| Project Title: | Fountain Wind Project |
| Document Title: | LU-002_LandUses1mile |

Fountain Wind Project Response to CEC Data Request LU-002

Follow-up Data Request LU-002:

V:\11950\active\Task_Owner and other Non-BCI\956_Joist\185703743\03_data\gis\cad\gis\mxd\2023\LU-002_LandUses1mile.mxd Revised: 2023-06-21 By: garpentier

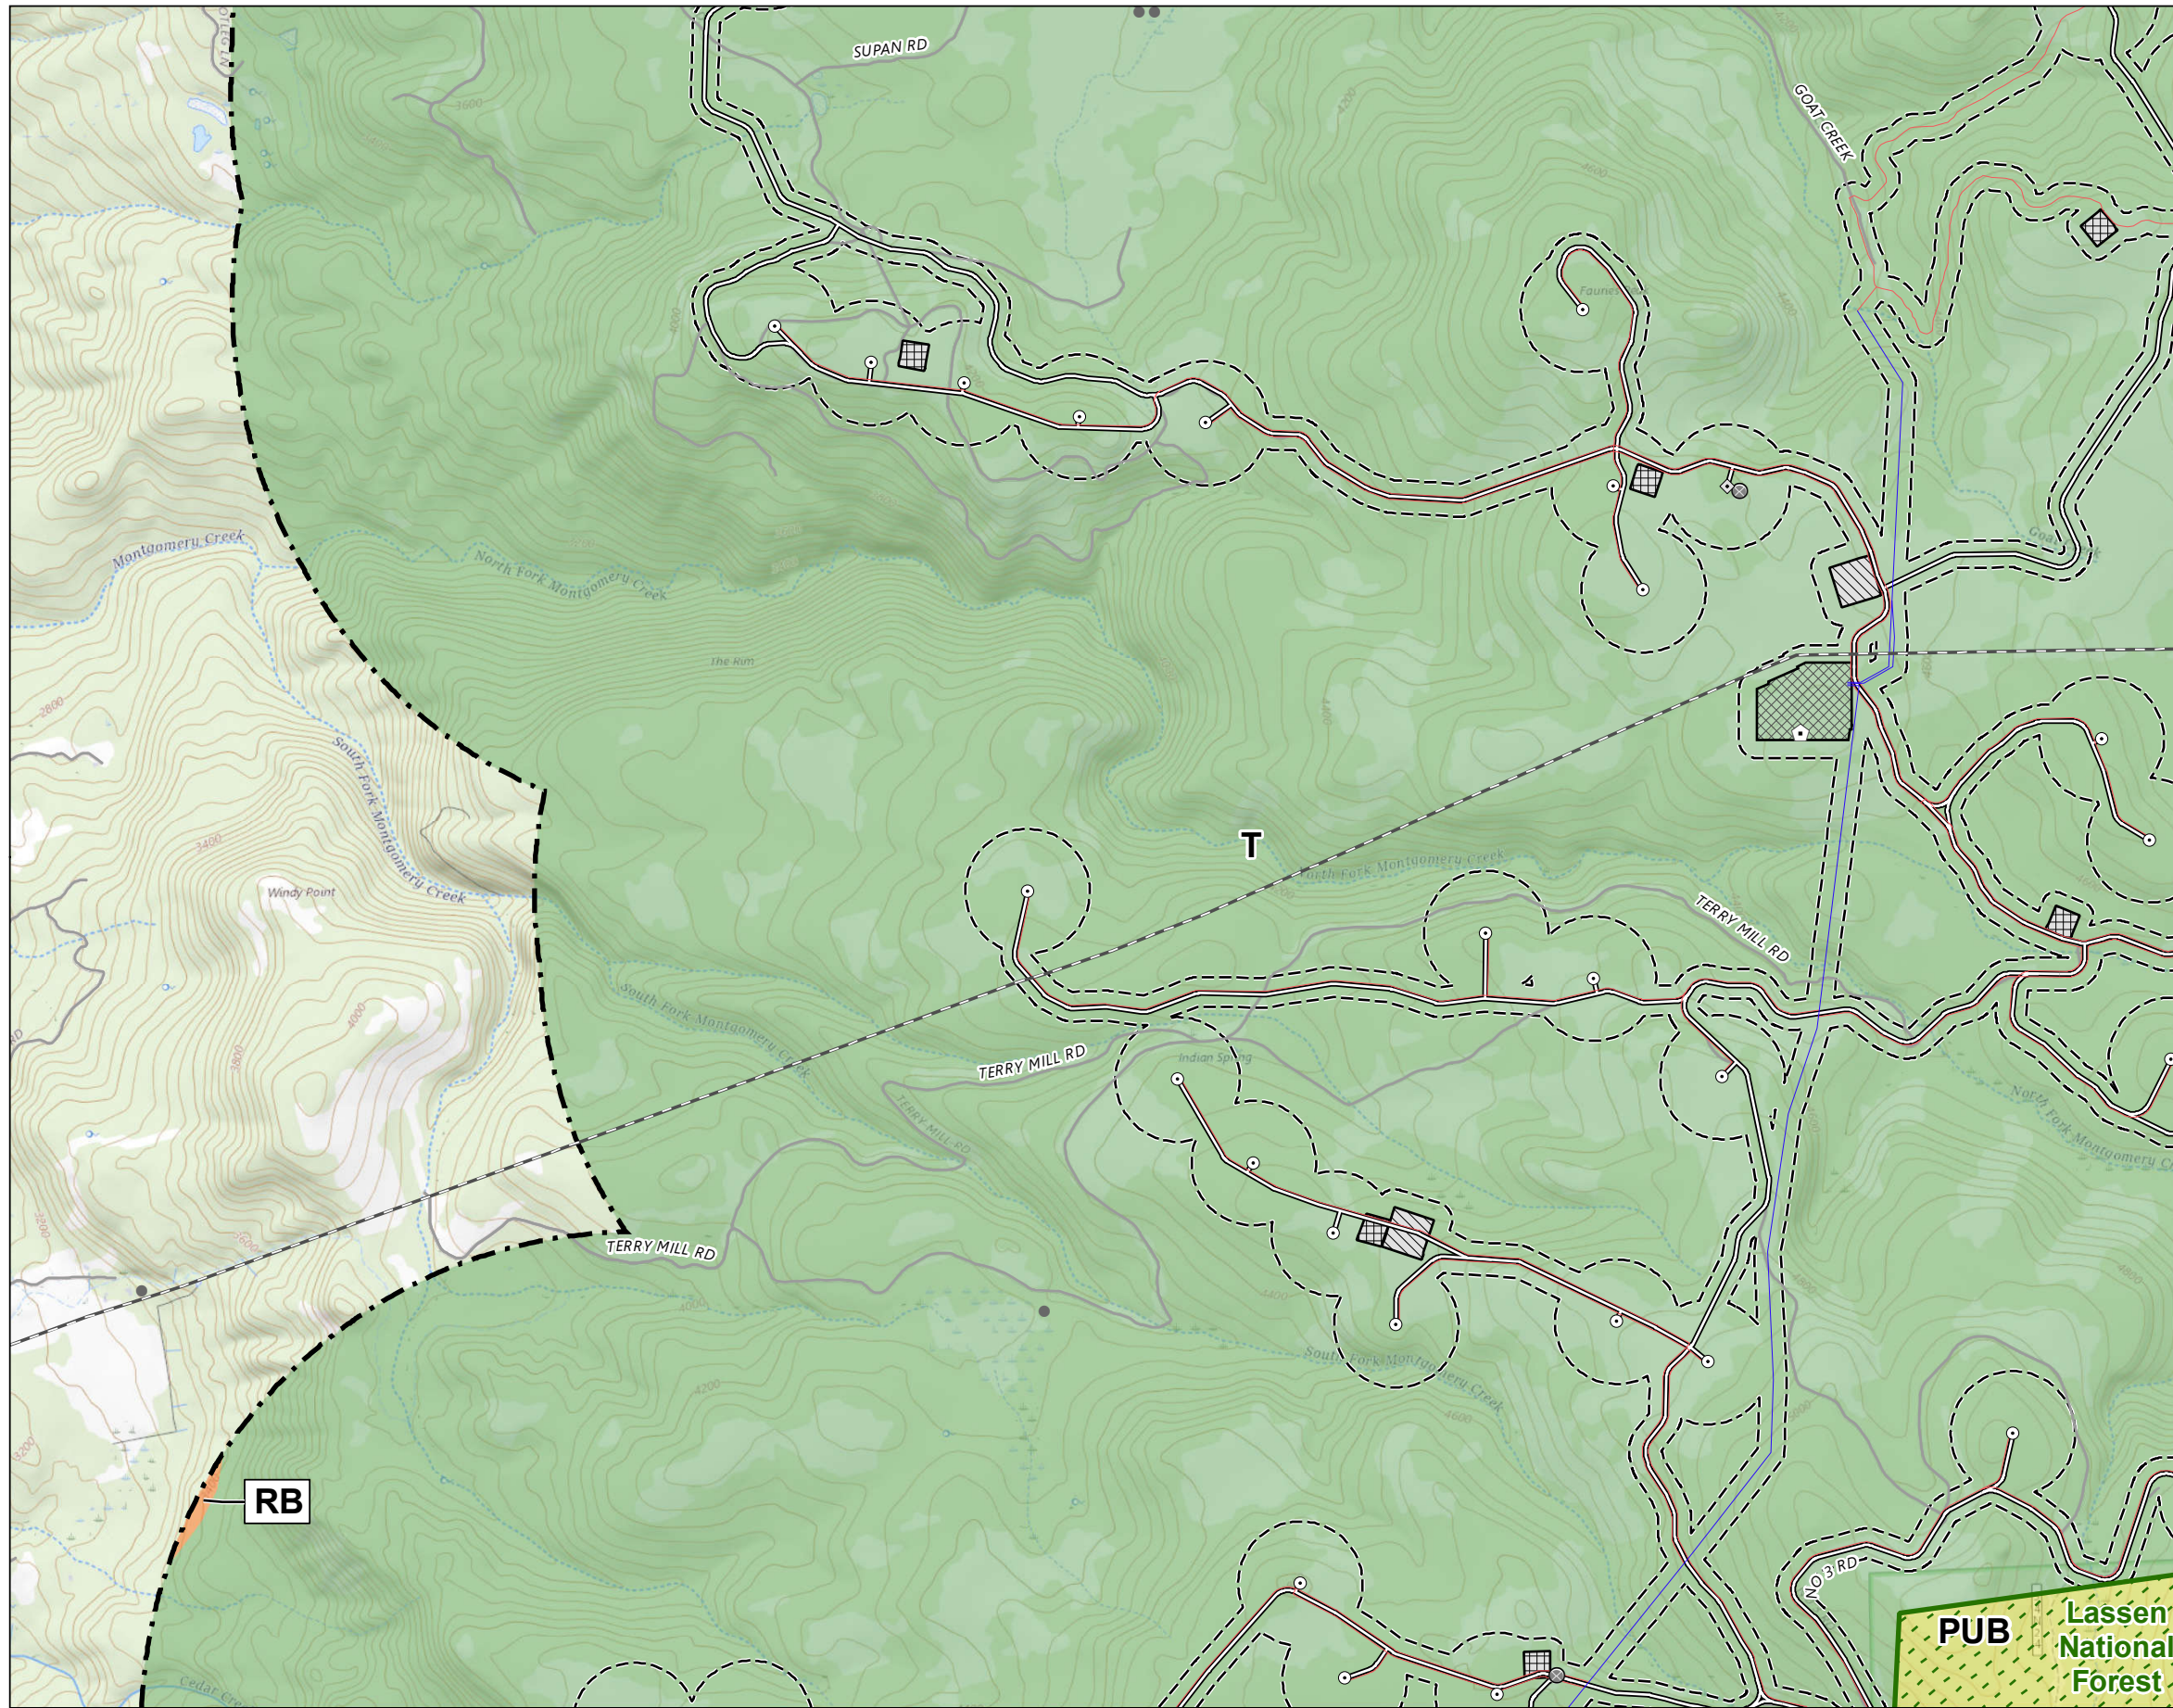
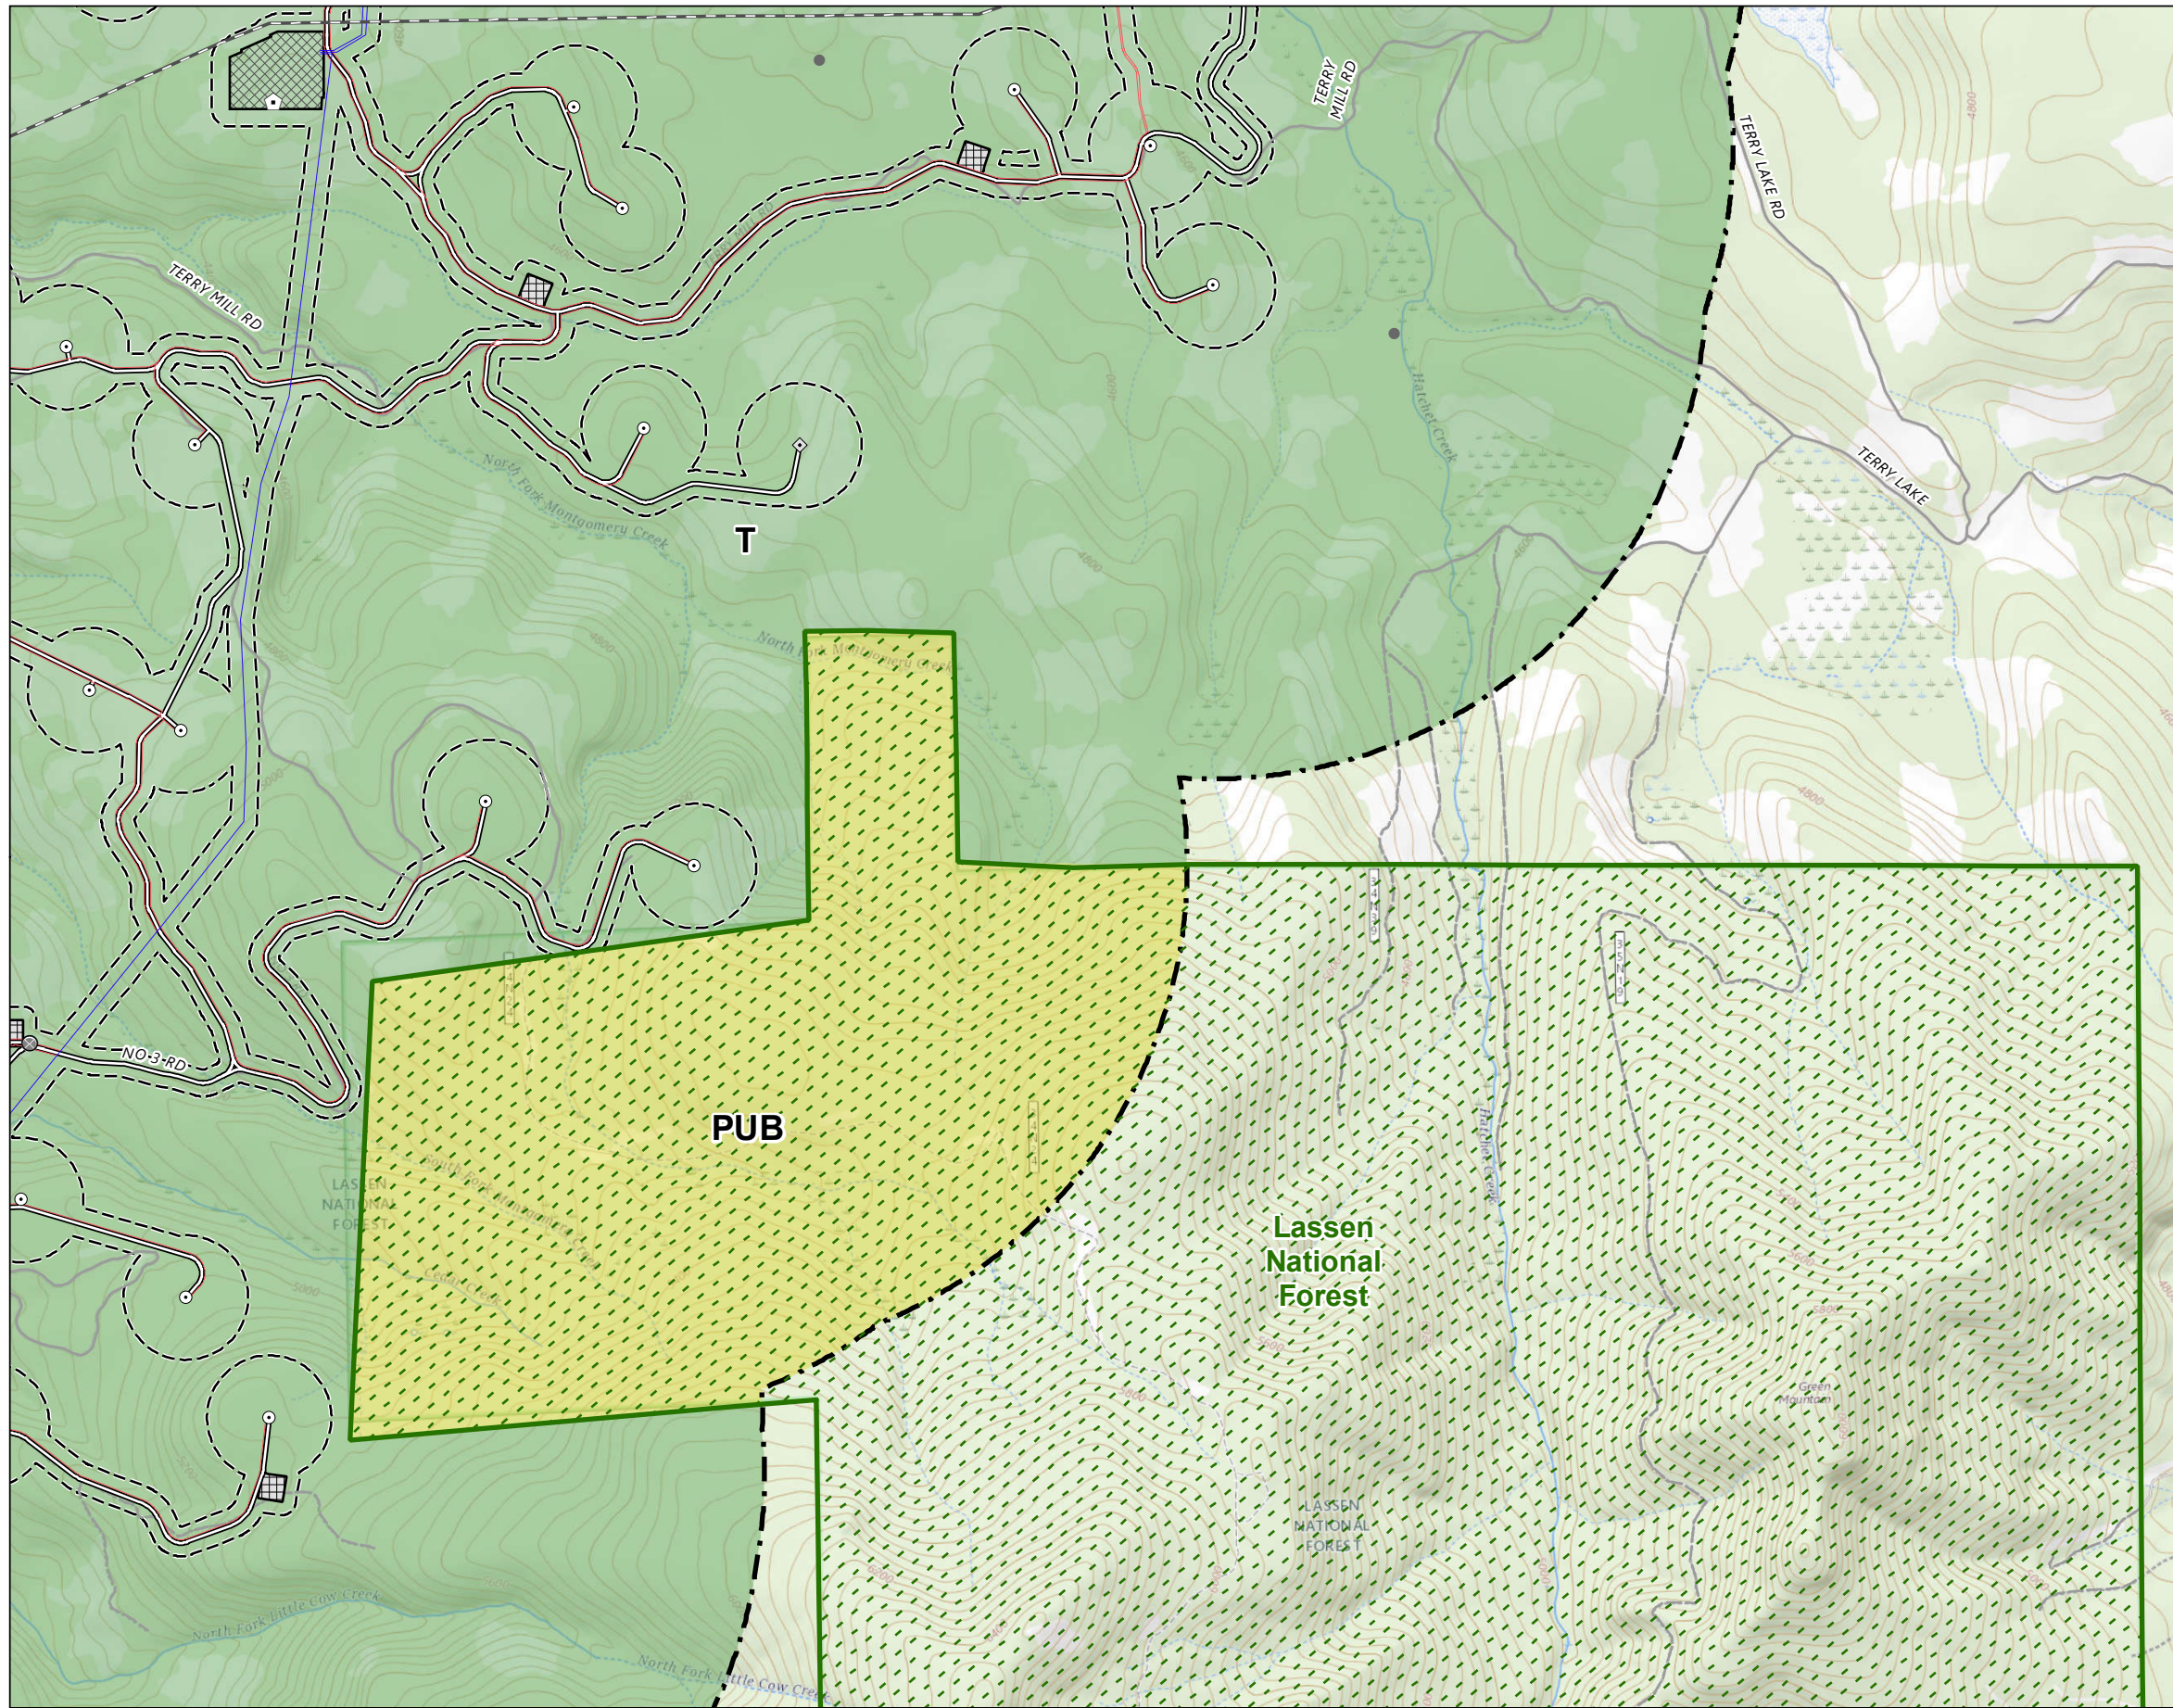
The information submitted is incomplete. TN 250283 (LU-02_LandUse) and TN 250448 (land_use_fwp_responses) are not adequate responses to the Warren-Alquist Act Siting Regulations Appendix B (g)(3)(A) and Appendix B (g)(3)(A)(i).

- The Project Site Boundary (i.e., the boundary that encompasses all project activities).
- The 1-mile buffer from the specific proposed Project Site Boundary, as required by the Warren-Alquist Act Siting Regulation Appendix B (g)(3)(A). The “buffer” illustrated in TN 250283 is not accurately shown as extending 1-mile from the project boundary. Note that a “project area” is not a specific project site boundary. The Applicant needs to provide the specific boundary upon which the Project would be sited to allow for CEQA impact analysis.

- The location of zoning designations that are identified in the figure legend for TN 250283 (i.e., Rural Residential is shown in the legend but is missing on the figure).

- Per the Warren-Alquist Act Siting Regulation Appendix B (g)(3)(A)(i), a discussion of existing physical land uses within the Project Site Boundary and 1-mile buffer area that include “residential, commercial, industrial, recreational, scenic, agricultural, natural resource protection, natural resource extraction, educational, religious, cultural, and historic areas, and any other area of unique land uses.” This discussion must include a description of the total numbers and locations of any existing residences; recreation facilities such as parks & trails; schools; commercial/retail sites; industrial uses or other land uses. Note that land use designations (i.e., general plan and zoning) are not the same as existing physical land uses currently occurring on the project site.

See revised figure LU-002. The Project Site Boundary includes all project features and all areas in which ground disturbing activities could potentially occur, and the associated construction and maintenance corridors and is depicted on Figure LU-002. Appendix B does not require an applicant to provide the total numbers of existing residences but the Applicant nonetheless estimates that there are approximately 50 rooftops that may be houses in the second home community of Moose Camp, and an additional 15 or so scattered throughout the 1-mile buffer. The remaining physical land uses are included in the table below.
